SPARC Enterprise M3000/M4000/M5000/ M8000/M9000 Servers

Product Notes for XCP Version 1122

Manual Code: C120-0048-01EN
November 2016, Revision A

M9000 Servers Installation Area

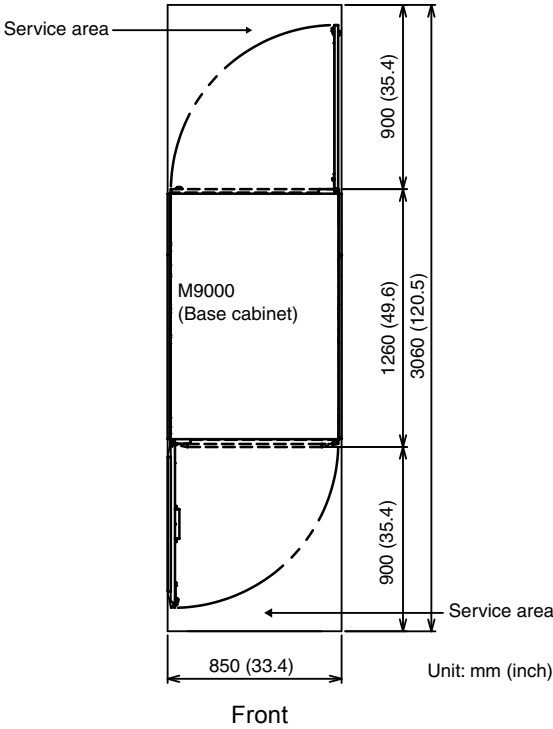
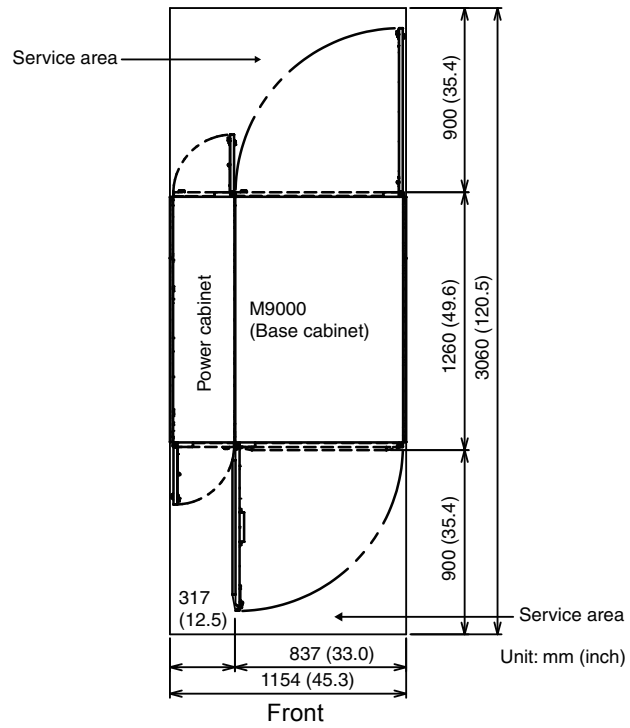
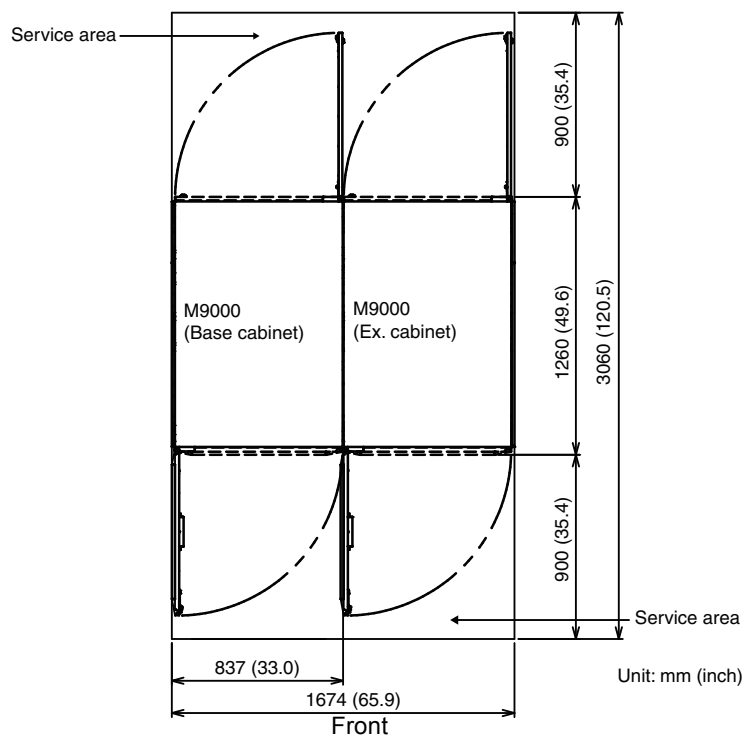
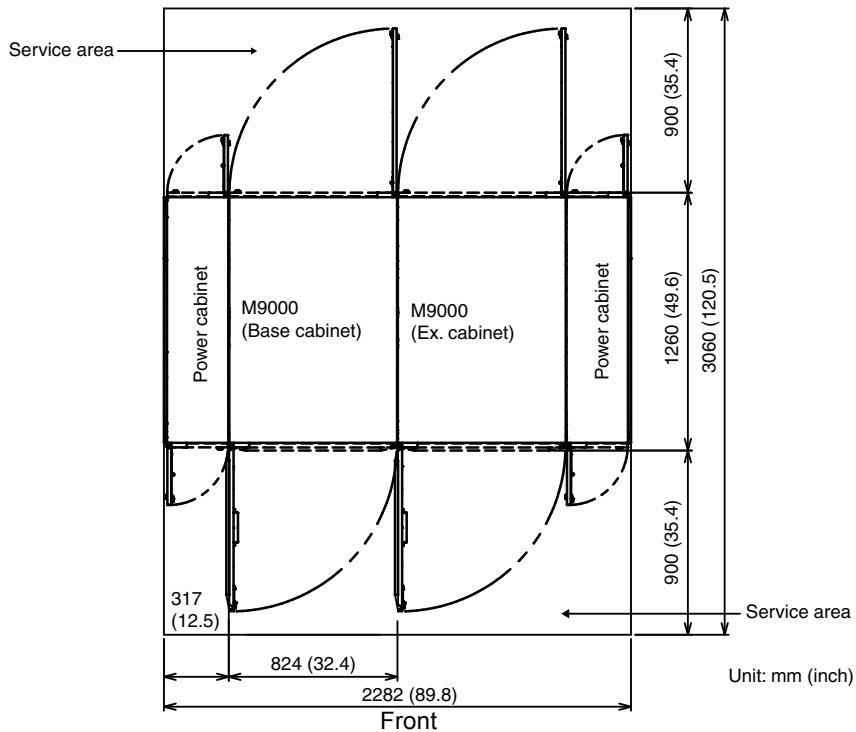
SPARC Enterprise M8000/M9000 Servers Site Planning Guide	1-18	A part of values in inches on FIGURE 1-13 to FIGURE 1-16 will be corrected. For detail, see “M9000 Servers Installation Area” on page 121.
	1-35	For the order number of Vibration-proof bracket and Vibration-proof feet, see “Miscellaneous Information” on page 125.
SPARC Enterprise M8000/M9000 Servers Service Manual	7-8	The mounting location of I/O Unit (IOU) indicated on FIGURE 7-4 will be corrected. For detail, see “I/O Unit (IOU) Mounting Locations” on page 124.”

The following information supersedes the information in the *SPARC Enterprise M8000/M9000 Servers Site Planning Guide*

FIGURE 7-4 IOU Mounting Locations (Front of M9000 with the Expansion Cabinet)

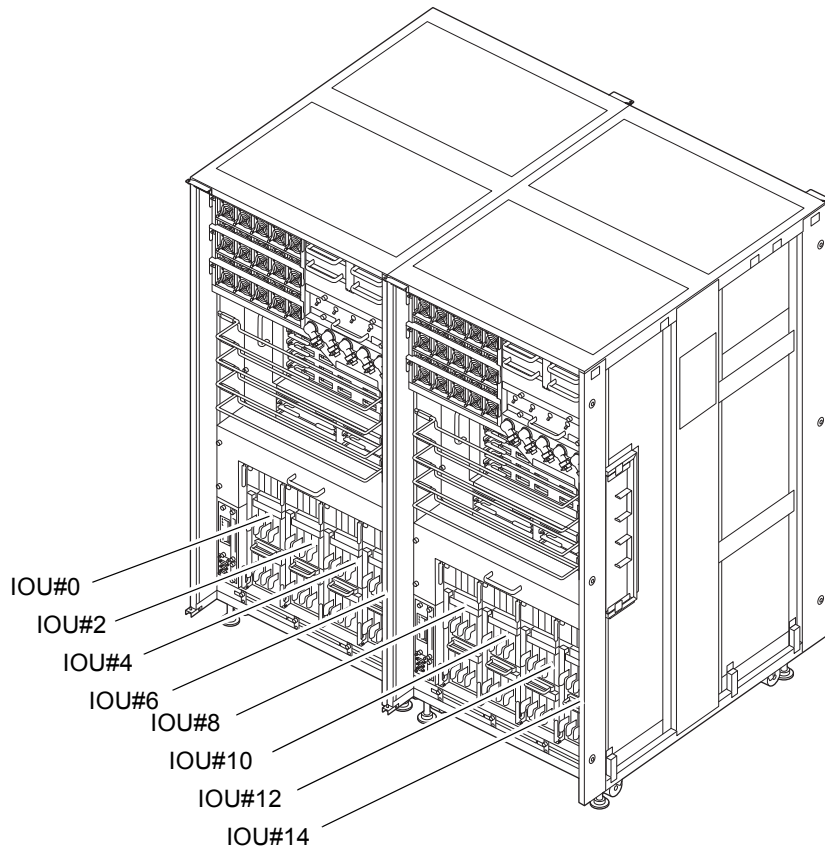
The following information supersedes the information in the *SPARC Enterprise M8000/M9000 Servers Service Manual*.
